GENERAL NOTES AND REMOVAL OF ORGANIC MATERIAL

LAST REVISION 11/01/17	DESCRIPTION:	 FY 2019-20 STANDARD PLANS	SUBSOIL EXCAVATION	INDEX 120-002	SHEET 1 of 2
---------------------------	--------------	--	--------------------	------------------	-----------------

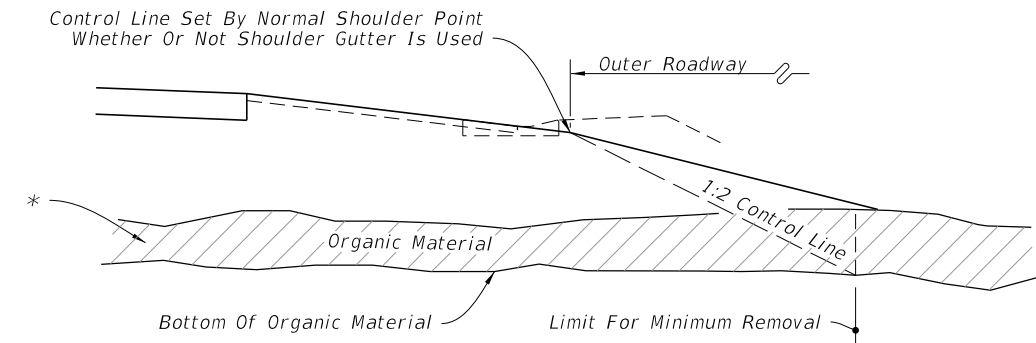
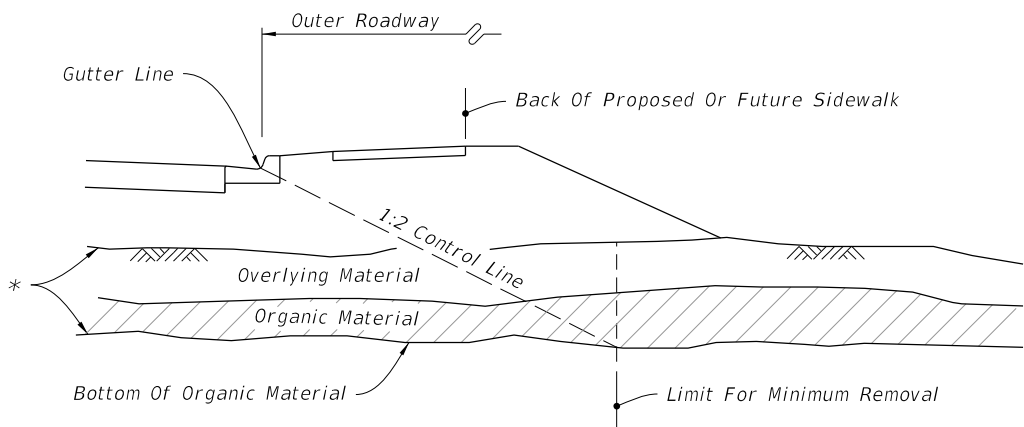
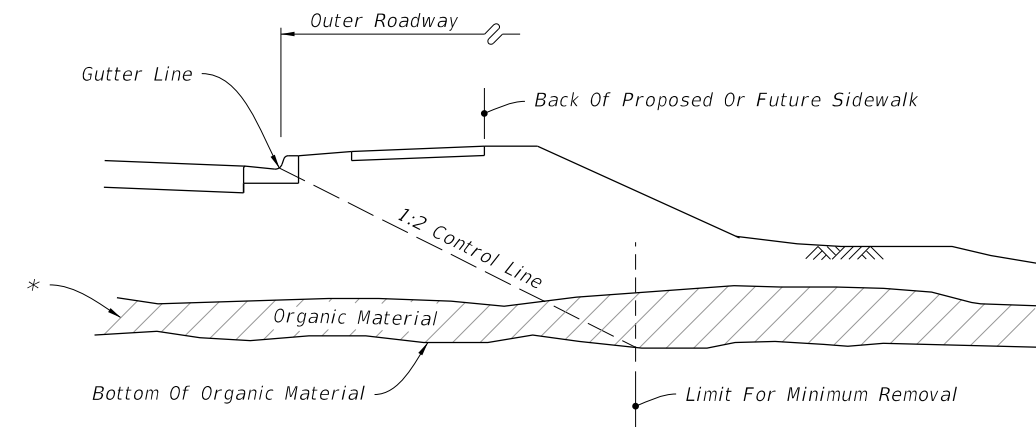
7. In areas of curbed roadway, where underdrain is to be constructed beneath the proposed pavement, the grade of the underdrain filter material will not extend above the bottom of the stabilized section of the subgrade. Gradation of the filter material must conform to Standard Specifications. The minimum grade of underdrain pipe is ~~0.2%~~

CORRECTED: 0.2%
